Interactive comment on "Climate elasticity of streamflow revisited – an elasticity index based on long-term hydrometeorological records" by V. Andréassian et al.

V. Andréassian et al.

Fig. 1.

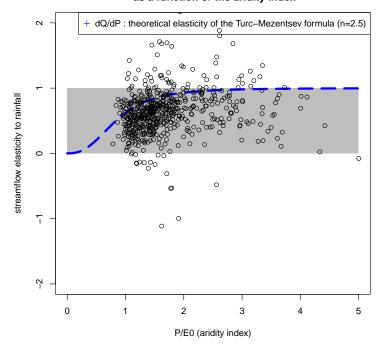
- 5. Last, we did check (see attached file) whether the link between empirical and model-elasticity is a function of the aridity index P/E0. Indeed, as underlined by Alberto Viglione in his review, there is a clear pattern in the theoretical elasticity that can be deduced from the Turc-Mezentsev formula. But as shown by the attached figures, the aridity ratio does not explain much of the large différences between empirical and model-based elasticities.
